INDESIT company

Model type:
BSZ3021V

Commercial code:
F055933

0521123: SEALS FOR DOORS FOAMED AS ONE PIECE

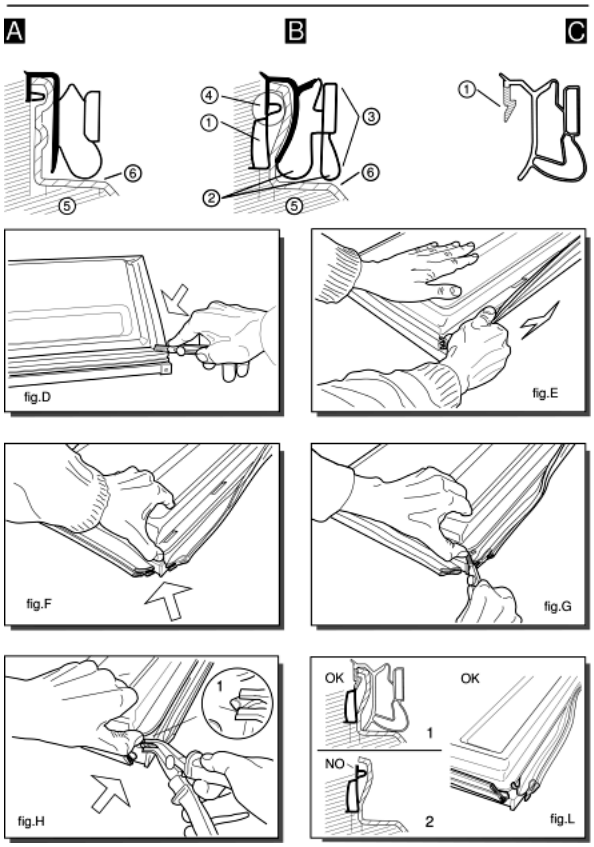
Various types of gaskets with different profile, as shown in figures (A) and (B), are used to fix the door (fig. A-5; B-5) and the inner door (fig. A-6; B-6) on the block foamed doors of combined freezers and refrigerators.
---Ilpea profile 245; 179; 412 (fig.A)
---Ilpea profile 287 (fig.B)
When replacing gaskets with profiles 245; 179; 412 these are fixed with screws (2 per corner) to the door.
Gaskets with profile 287 can not be used as spare parts but are designed to house the Ilpea type 900 gaskets (see figure C).
When replacing the gasket (287), once it is removed you will find a pocket (fig. B-1) between the door and inner door.
The rigid tooth (fig.C-1) of the gasket (900) is inserted inside between the pocket and the inner door, doing away with the need for screws.
Gasket with profile 287 is easy to identify since it has an exterior double edge (fig.B-2) which acts as a cushion when the door is closed.

To replace this gasket, follow these steps:
---Dismount the door and cut the four corners of the gasket along the joint (fig.D);
---lift the gasket and pull it carefully along its full length without tearing it (fig.E).
The purpose here is to detach the inner door slightly from the foam along the exterior edge for a depth equal to that of the gasket (fig.B-3);
---lift the corner of the inner door slightly, prising it up with your thumb (fig.F). Do not use a tool which might break the inner door;
---continue cutting the gasket inside the inner door for about 6 mm (fig.G);
---push in the tip of the pliers (type USAG N131) and pull outwards until you see the top edge of the pocket (fig. B-4) which is empty (fig.H-1);
---if you carry out this operation correctly (fig.L) you will be able to pull off the top edge of the pocket for the full length of the door.
If the gasket tears before the top edge (fig. L-2) you should repeat this operation from the other corner of the door.

---once the gasket (287), has been removed the space above the pocket (fig. L-1) can house the rigid tooth (fig. C-1) of the gasket 900.
When you fit this gasket ensure that it lies flush against the edge for the full length of the door.
If the rigid tooth is difficult to fit, eliminate any residues of foam between the door and the inner door in the gasket area.
fig.5131549A
